GW - 293

Gallegos Compressor Station

**Re: Inspection Report, GW-293
Gallegos Compressor Station
San Juan County, New Mexico**

OCD Inspection: Williams Four Corners, Gallegos CS, GW - 293

Photo 3: Unlined AST.

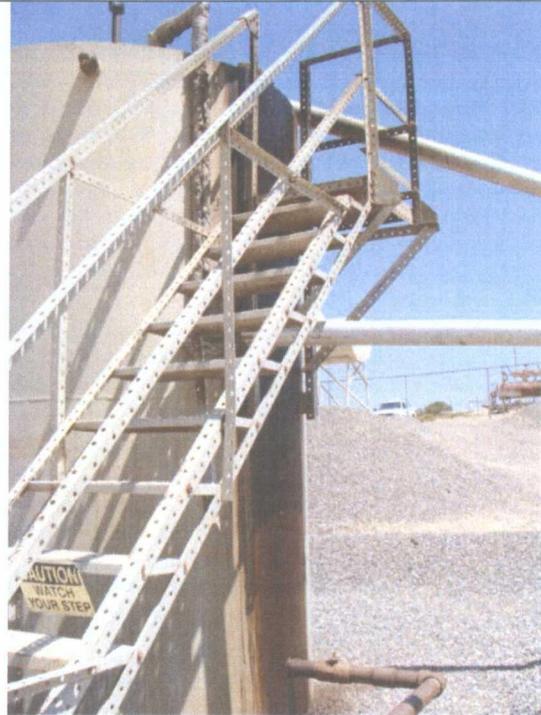
2. Photo 3: AST is not located on an impermeable secondary location. Williams Four Corners shall re-engineer AST to meet the permit condition requirements.

Photo 6: 5 gallon can over hatch of BGT.

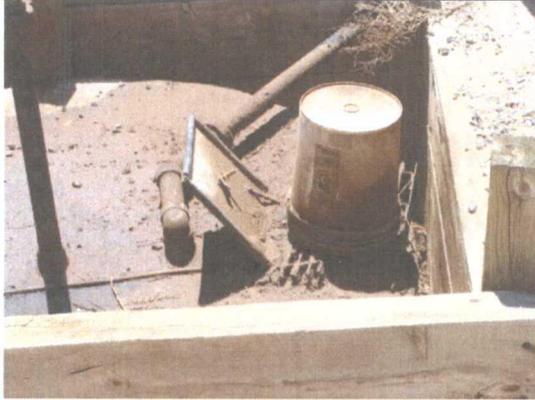
3. Photo 5, 6, 7: The side walls of the BGT are not visible. Clean around the BGT of debris and soil. Any unnecessary accumulation of fluids is recommended for any tank if possible. All ports and openings shall be covered at all times. The BGT appears to have overflowed at one time due to the amount of staining on the BGT top cover. The OCD requests the records for testing and monitoring of the BGT for the past five years.
